## BOARD OF ADJUSTMENT MEETING AGENDA

OCTOBER 3, 2023

## Woodspring Suites

## Cottages at Magnolia East

SHEET PLAN  
**C-102**

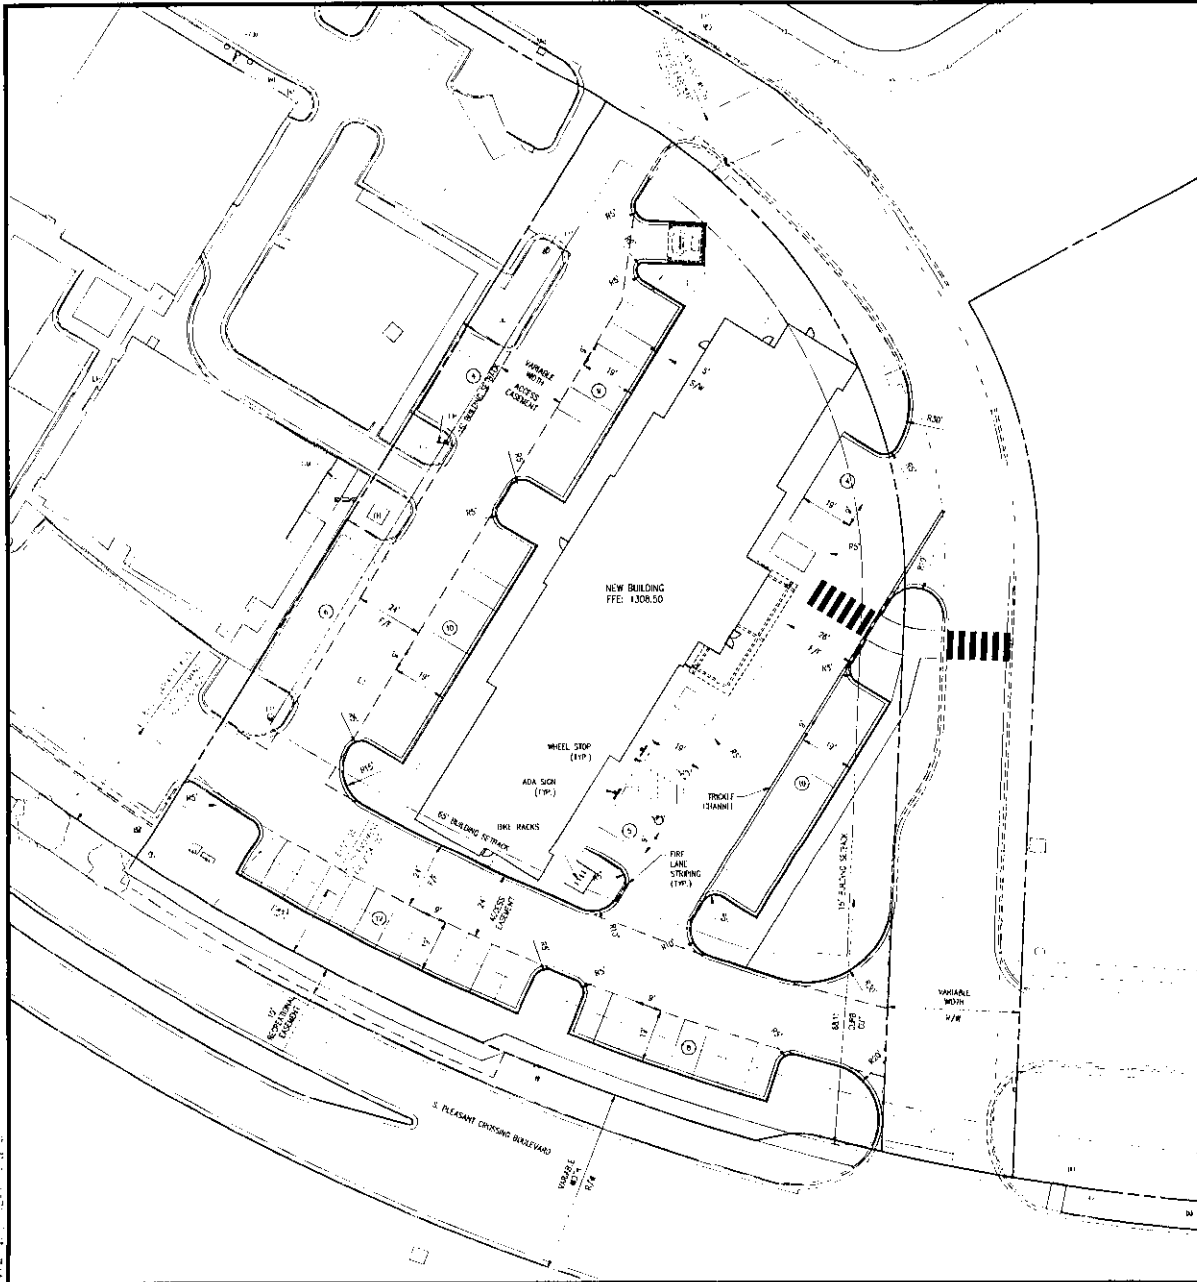
- Odd-shaped lot within a commercial subdivision; surrounded by right-of-way and private commercial access
- Long, linear shaped building doesn't quite fit within the bounds of the setbacks for this lot under the current site design
- Setbacks being encroached are based off of right-of-way or easements. Latest information tells us that the access drive on the east side of the development isn't an access easement.
- Building may be able to fit within the setbacks if it's rotated to fit adjacent to the eastern property line.

- Legally, drive along the eastern side of the property is a private drive. Discovered after first review that this is not right-of-way.
- Unclear where to establish side setback.
  - Relocation of eastern property line could alleviate need for side setback variance.

- **CONSIDER** variance for front and side setback encroachment

- Staff recommends consideration of the request.

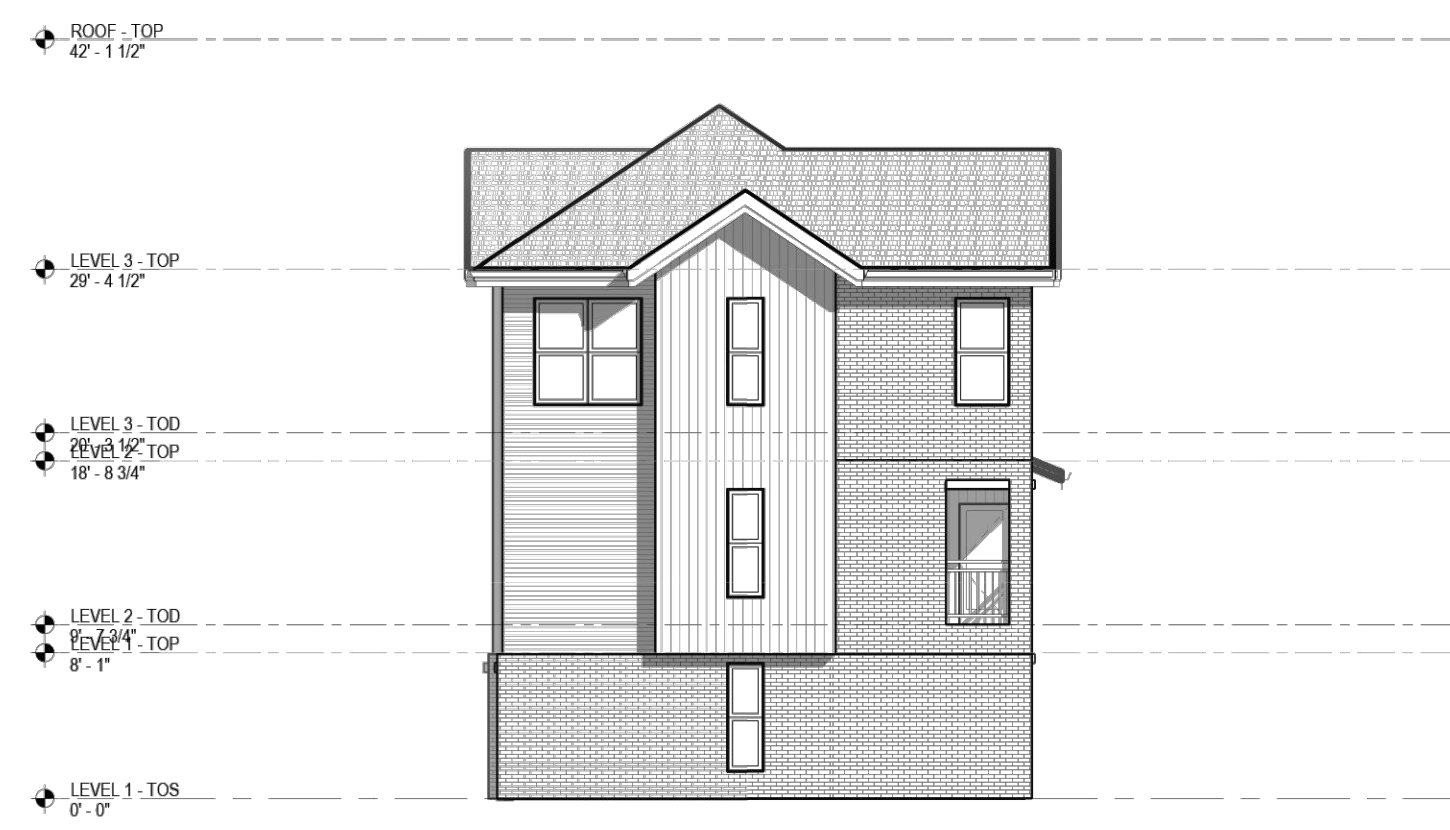
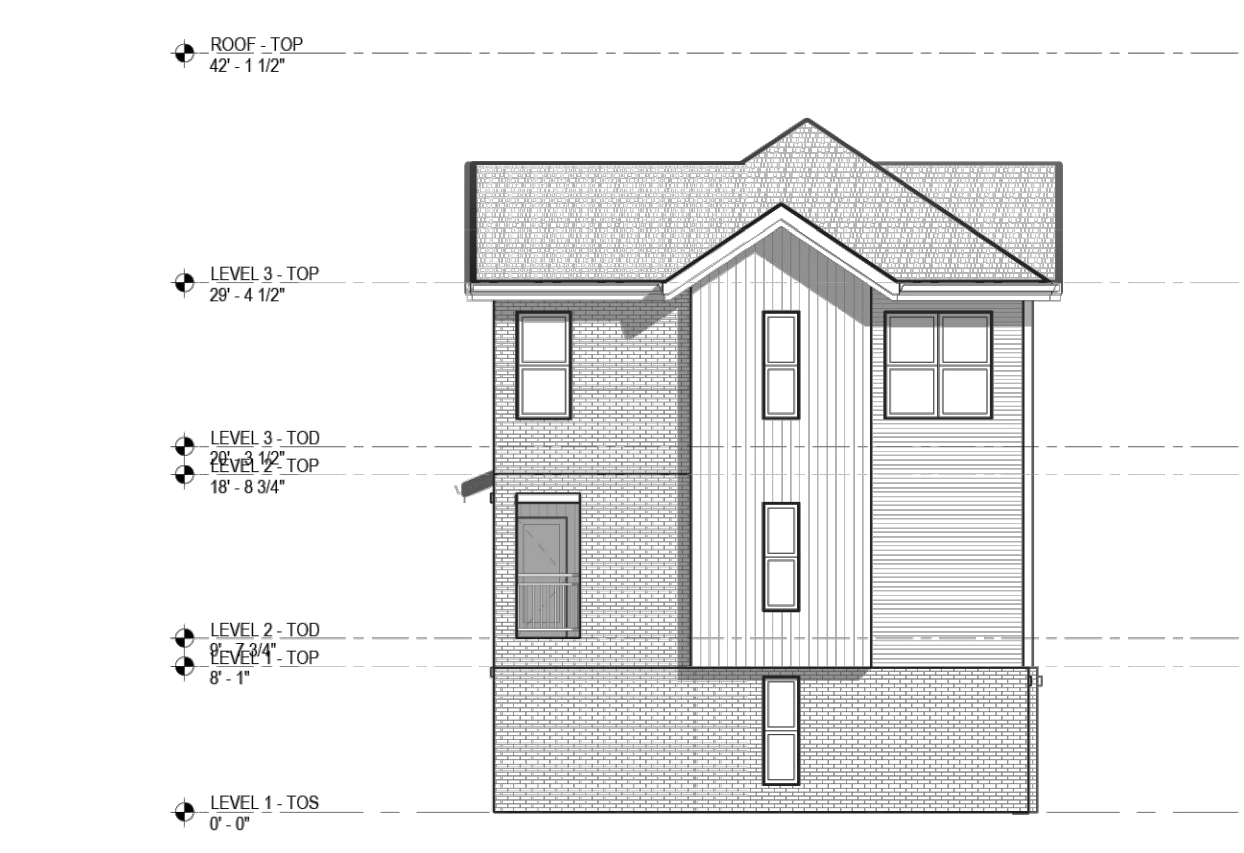
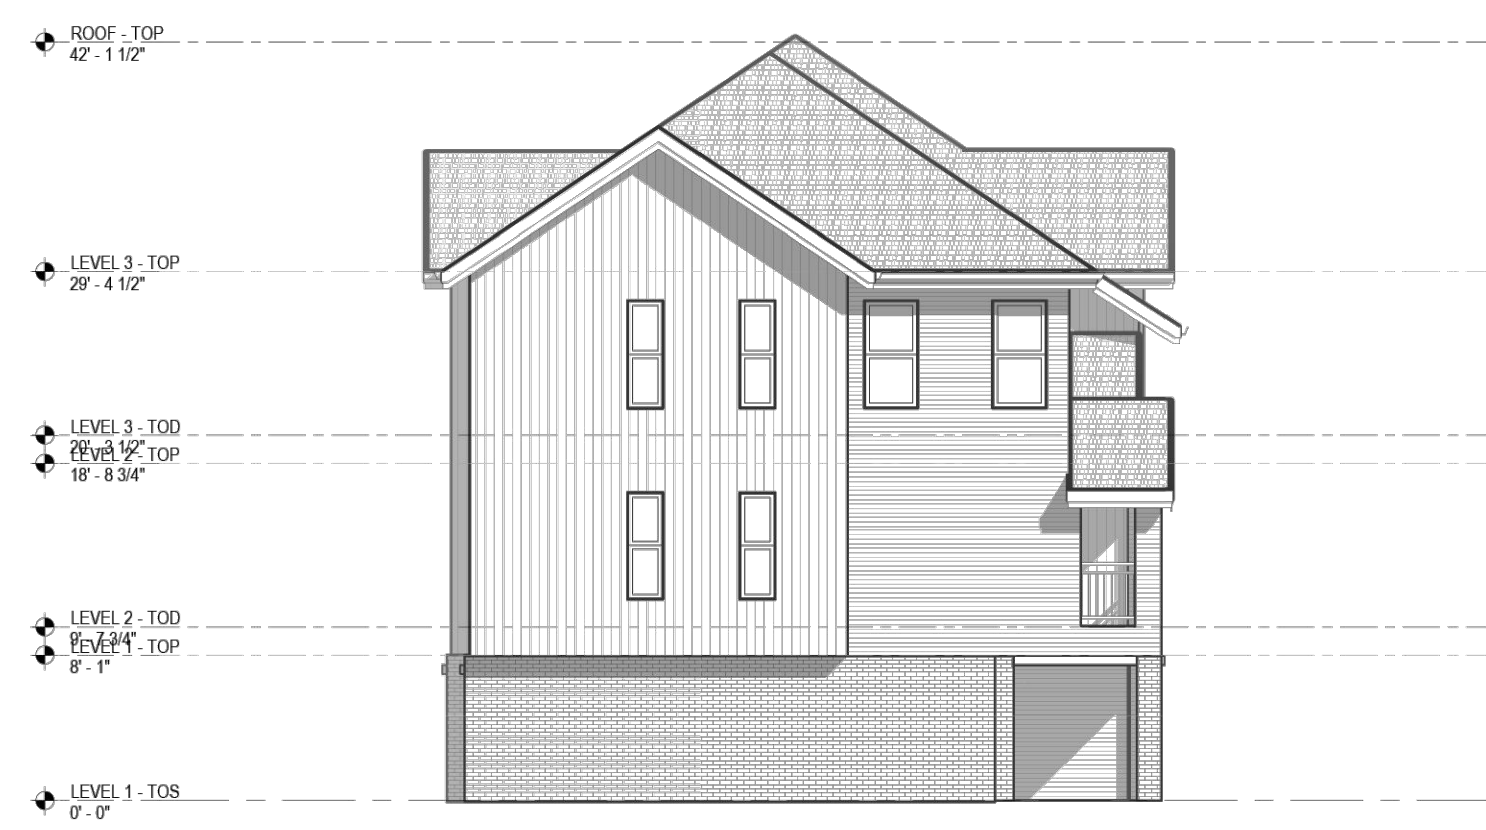
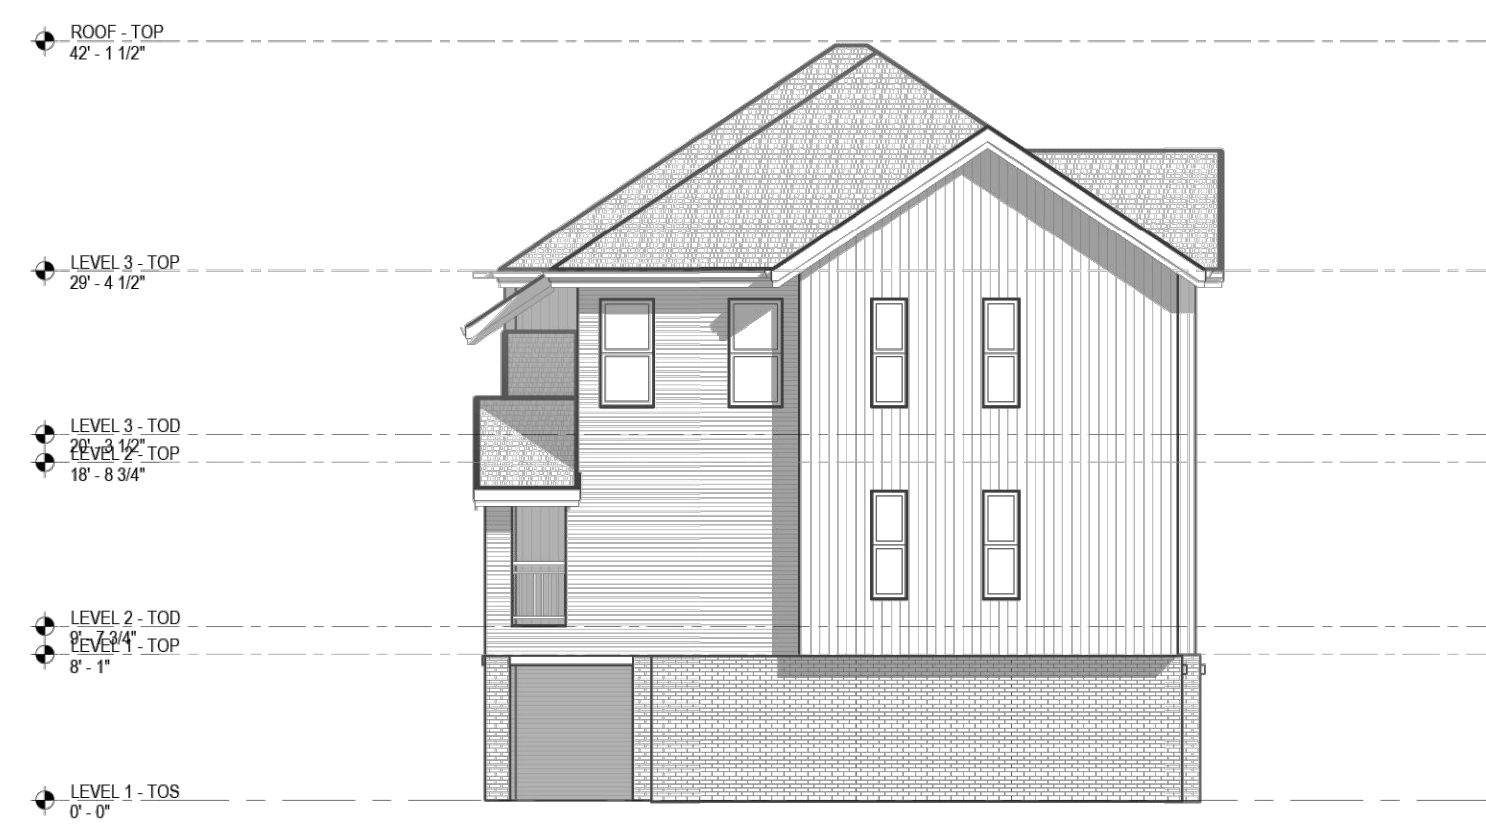
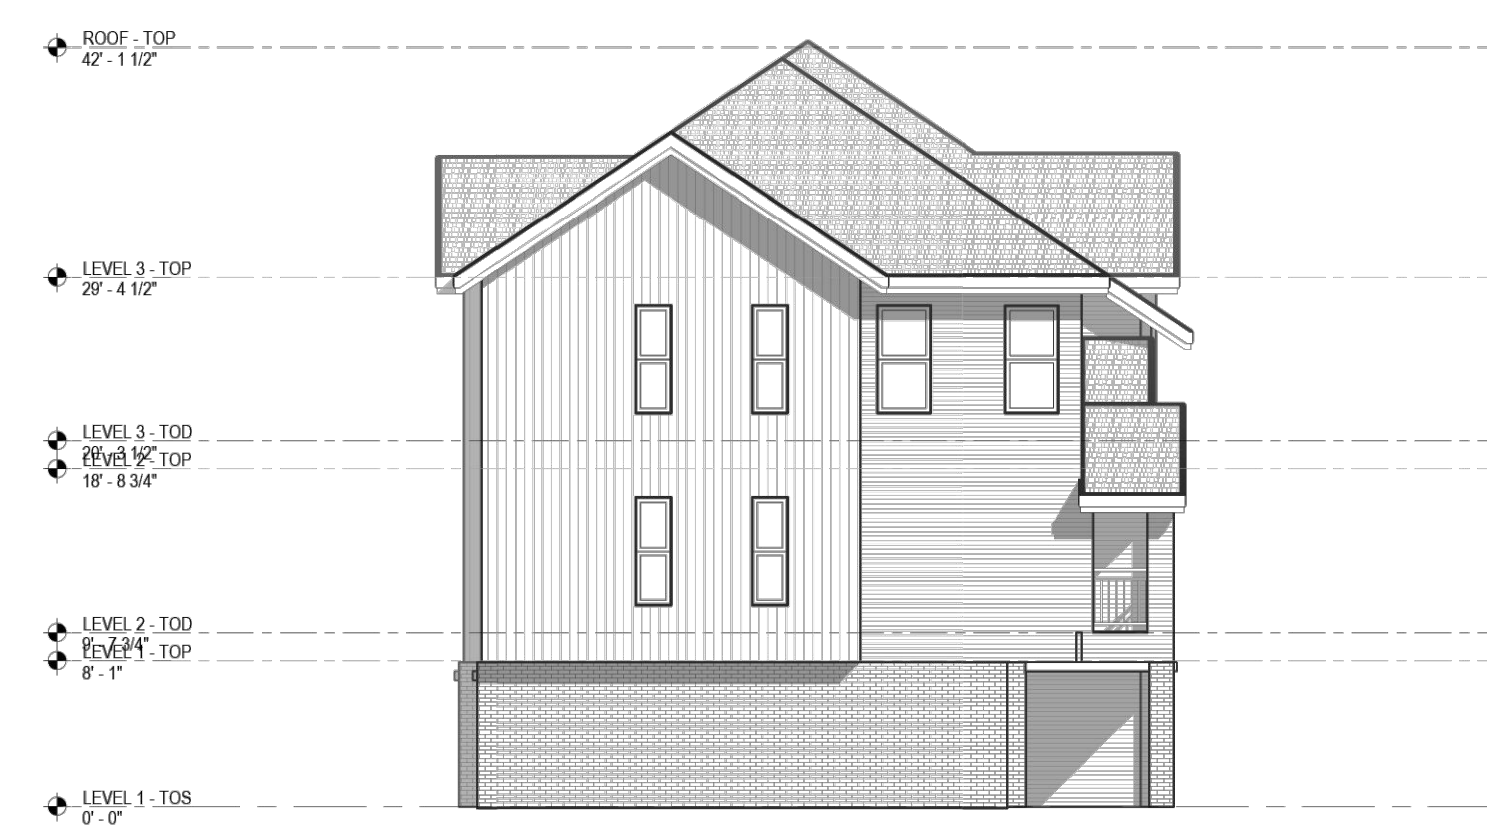
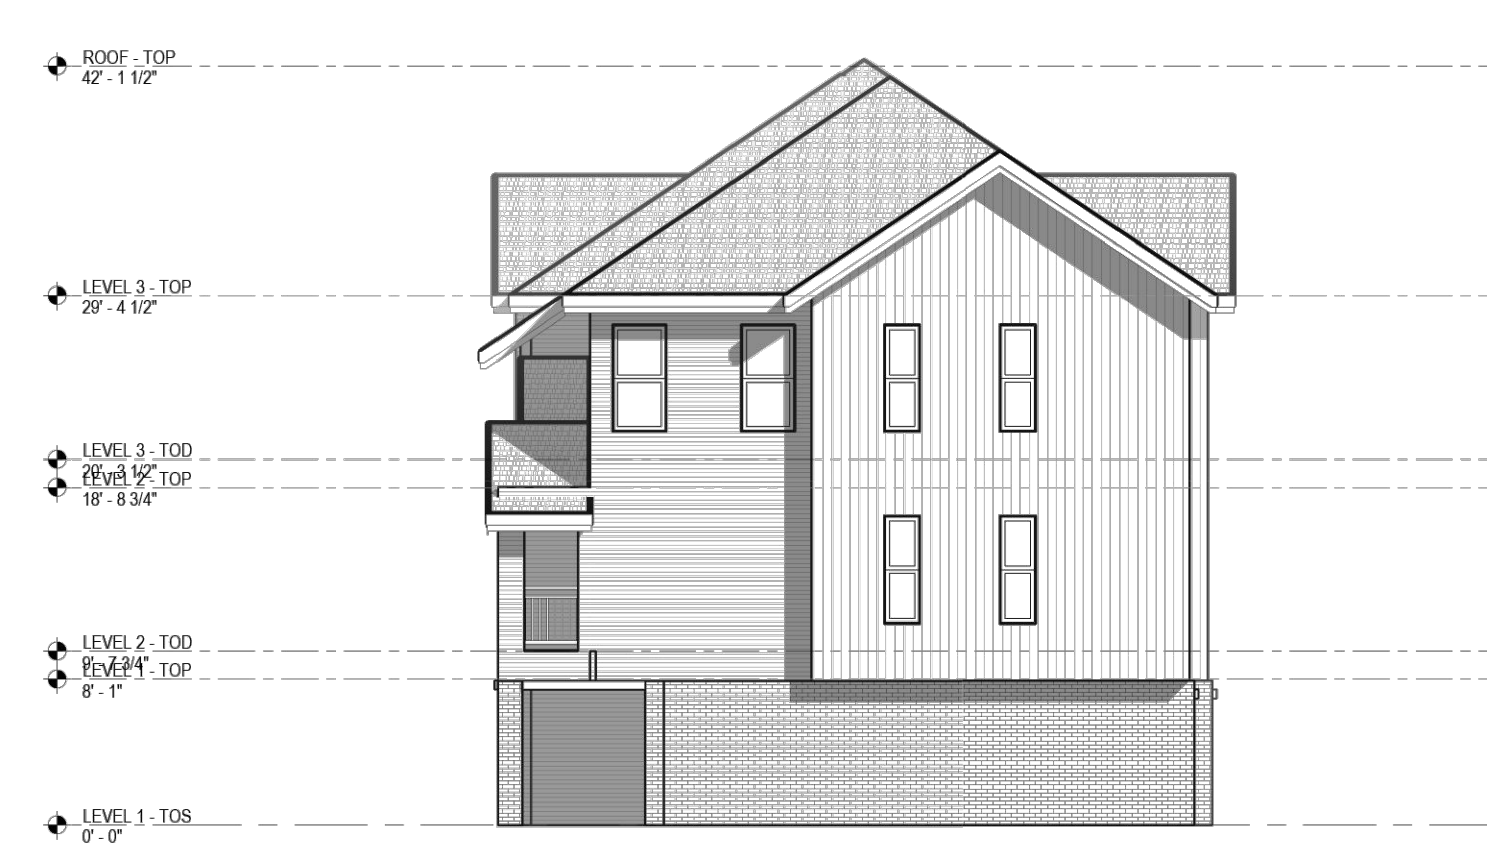
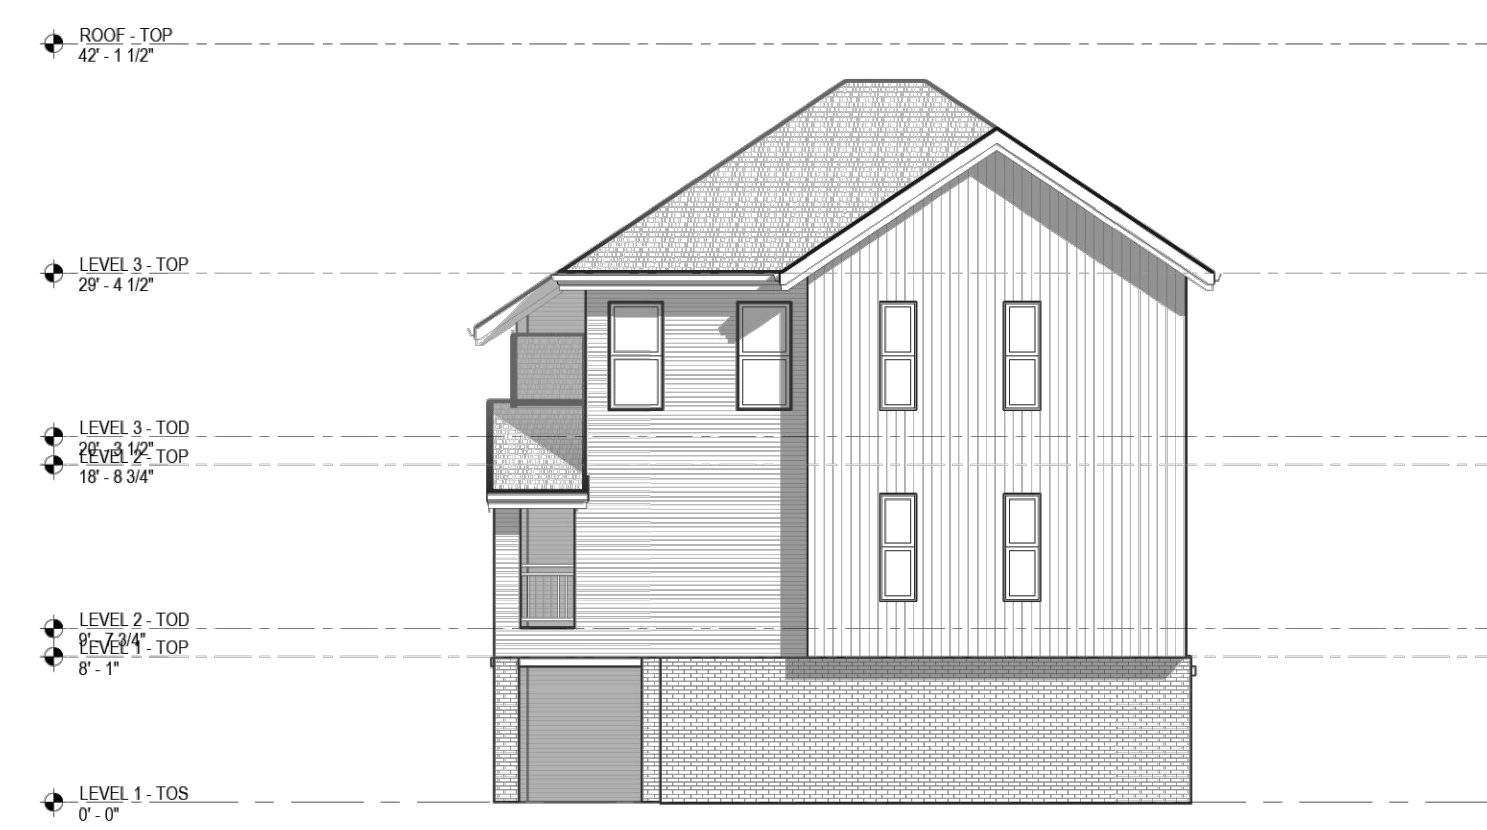
- To vary Sec. 14-732(4.5)(c)(i), which requires a first floor height of 12' for all frontages in a U-NBT development
- Proposed height of first floor in all units: 8'1"

- U-NBT zoning requires 12' first floor, to account for the possibility of a commercial use on the first floor.
- Development is proposing 8'1" first floor.

- Lot fronts S 43<sup>rd</sup> Street, a minor street that parallels S Promenade Blvd, a major arterial.
- Proposed development is being built to the urban form that URDC calls for, while also featuring garages and street parking.
- Subject property is designated for NBT growth, within the commerce corridor. This is intended to act as a residential buffer between potentially intense commercial uses in Commerce Corridor and adjacent Neighborhoods.
- Staff cannot guarantee that future developments in the area will contain commercial uses.

- S 43<sup>rd</sup> Street functions more as a side street, compared to an arterial like S Promenade. Not very much commercial viability within NBT form at this location.

- Proposed development utilizes urban form, street parking and garages and features no surface parking, while providing efficient housing. *“The purpose of the Uptown Neighborhood Transition zone is to provide medium- to high-density residential infill between the other URDC zones and surrounding existing residential neighborhoods. U-NBT development is typically characterized by residential structures that are single-family, 2- to 3-stories, with very small or zero side setbacks, such as brownstones, townhomes, garden homes, or similar housing types that normally feature front on-street parking and rear- or side-entry garages.”*

- Commerce corridor has an NBT buffer designated along its edges to protect adjacent Neighborhoods from potentially intense C-2 or C-4 developments.
- In this area, the applicants have several multifamily/townhome developments under way. Staff recently received a mixed use medical and commercial development request just northwest of the subject property. Staff has not seen a full master plan for the area.

- **APPROVE** variance for first floor height reduction

- Staff recommends approval of the request.
